**TOWN OF BAY HARBOR ISLANDS
PLANNING AND ZONING BOARD**

FINAL AGENDA

**TOWN OF BAY HARBOR ISLANDS
COMMUNITY DEVELOPMENT
MEMORANDUM**

Subject: Proposed Single-Family Residence
1301 99th Street
Bay Harbor Islands Acct. No.: MB2017-65
MMPA Acct. No.: 01-0702-1052

1 SITE PLAN
1/8" = 1'-0"

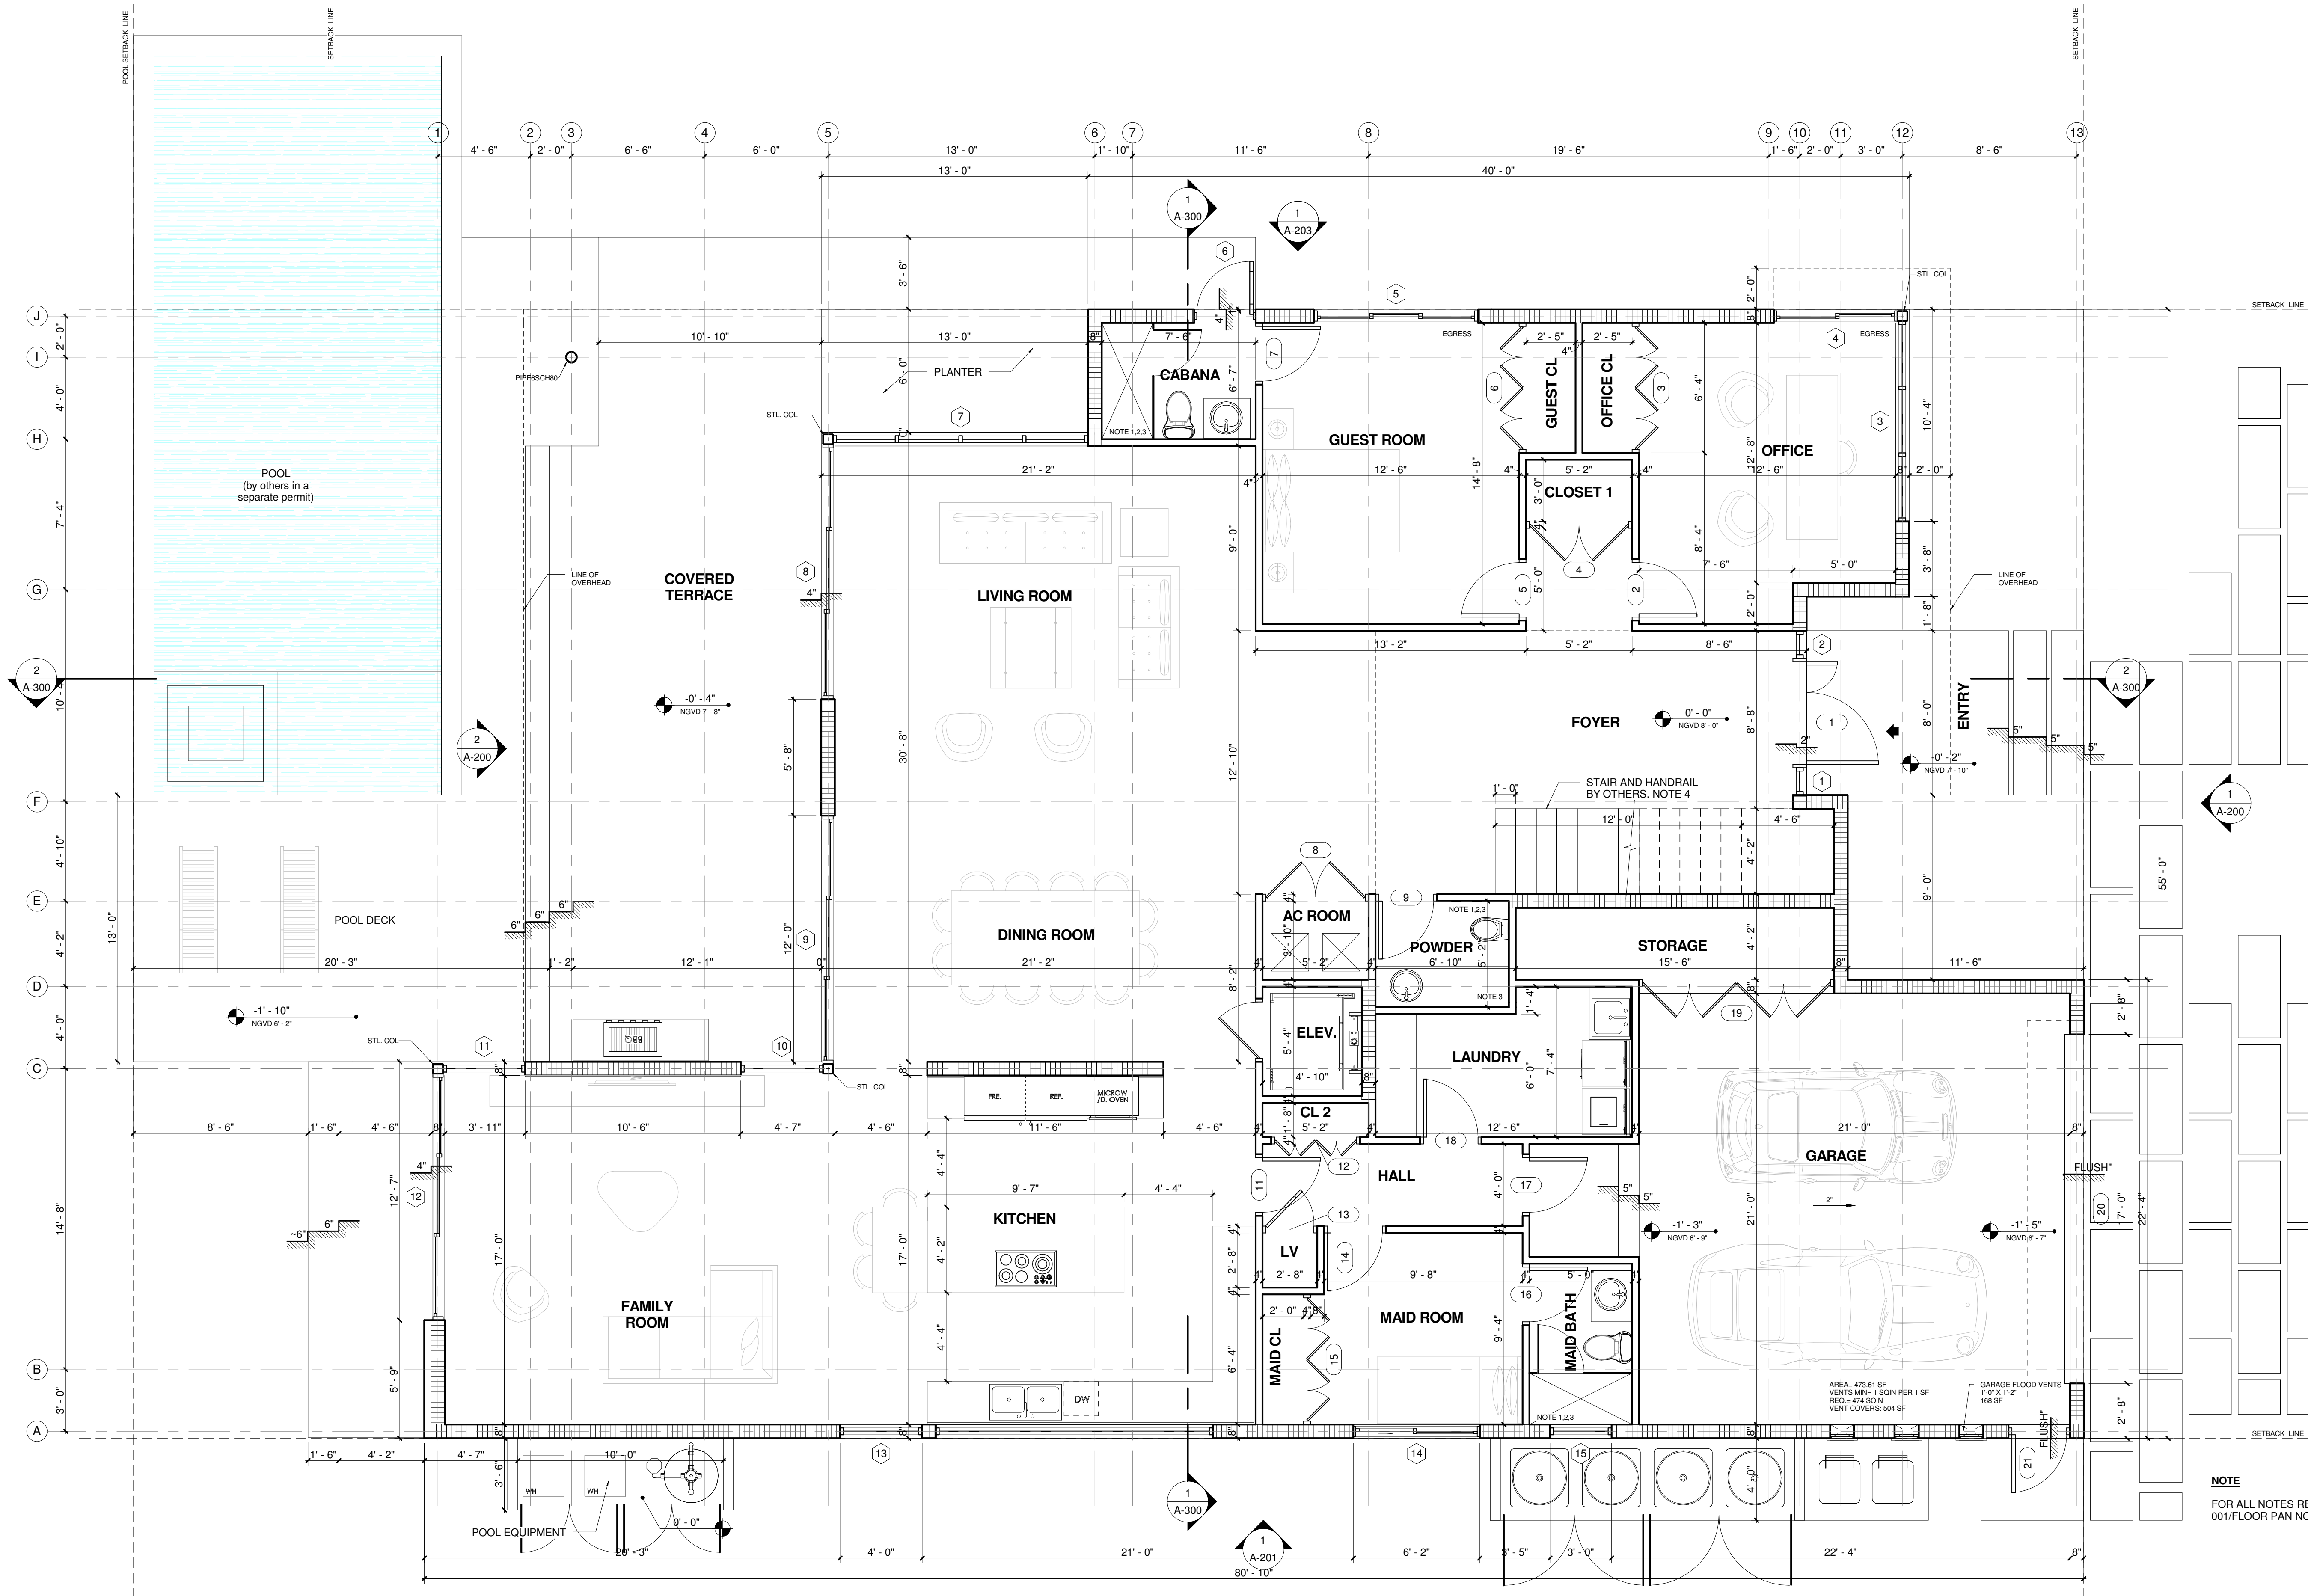
Flood Elevation (BFE), which is just under the maximum height permitted in the RD Single-Family District. The applicant is proposing two driveway connections to 99th Street. Extensive landscaping is existing / proposed that meets the Miami-Dade County Landscape Code and Town Supplemental Landscape Code requirements, including the use of native and drought tolerant plant materials.

The Town's current Street Tree Master Plan identifies the tree species for this area of the Town as Live Oak along 99th Street and Glaucous Cassia along Broadview Terrace. The applicant complies with the required street trees along the front of the site.
